## REVISED RESPONSE TO REQUEST FOR ADDITIONAL INFORMATION

### APR1400 Design Certification

Docket No. 52-046

RAI No.: 226-8235  
SRP Section: 03.07.02 – Seismic System Analysis  
Application Section: 3.7.2  
Date of RAI Issue: 09/25/2015

Figure 1 The FE model for RCS in SSI and structural analyses

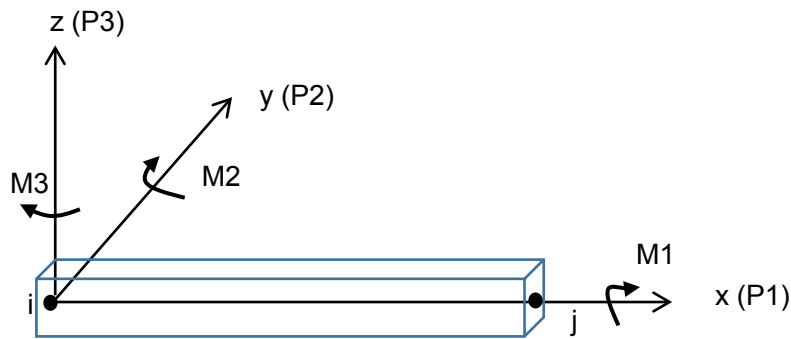
To assist the staff in evaluating whether the aforementioned masses and their effect have been adequately considered in the seismic analysis and design, the staff requests the applicant to clarify if these masses are included in or excluded from the FEMs used in the SSI analyses. If the hydrodynamic masses were included in the FEMs used in the SSI analyses, describe the process used to estimate the slosh height. If the masses described in the paragraph above are excluded from the FEMs used in the SSI analyses, describe the process (including a numerical example) for developing design loads that correspond to these masses and how these loads are combined with the seismic design loads. Additionally and as necessary, correct any inconsistencies between the aforementioned technical reports.

The RCS FE model (same as in SSI model) is included in the structural analysis model for the internal structure in order to consider the effect of RCS mass, as shown in Figure 1. It is made up of beam elements (BEAM4 in ANSYS) and mass elements. To connect the RCS model and internal structure, the rigid beams shown in yellow in Figure 1 are used. Table 1 summarizes the comparison of member end forces from the SSI analysis to those from the structural analysis at the major RCS frame supports.

Since the results of member end forces in the structural analysis are greater than those in the SSI analysis, the RCS masses are adequately considered in the structural design.
